Modification **B**ulletin

Model: Triton-C1 ADF (DF81)			Date	e: 3-Jun-05		No.: MB721001		
Modified Article: Grounding Tape				Prepared by: M. Tsuyuki				
From: 1st Tech. Support Sec. Service Support Dept.								
Reason for	☐ Parts catalog correction	☐ Vendor change		ange	☐ To n	neet standards		
Modification:	☐ To facilitate assembly	☑ To improve reliability☐ Other		()			
	☐ Part standardization

Model: Triton-C1 ADF (DF81)			Date	e: 2-Aug-05	;	No.: MB721002		
Modified Article: Holder Pad Etc.				Prepared by: M. Tsuyuki				
From: 1st Tech. Support Sec. Service Support Dept.								
Reason for	□ Parts catalog correction	☐ Vendor change		ange	☐ To n	neet standards		
Modification:	☐ To facilitate assembly	☐ To improve reliability		()			
	☐ Part standardization	☐ Othe	☐ Other

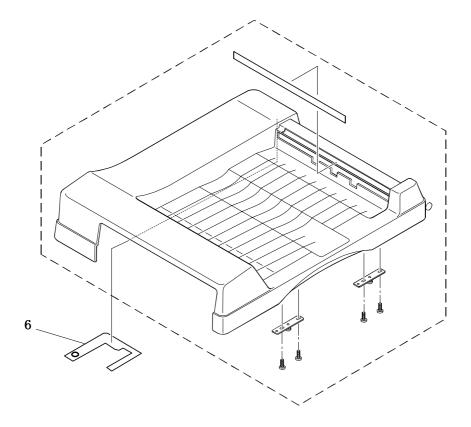
Change: Grounding tape was added. **Reason:** To reduce static electricity buildup and improve the stacking of the originals.

Old part number	New part number	Description	Q'ty	Int	Page	Index
	B7215006	Grounding Tape (6LA56652000)	1		11	6
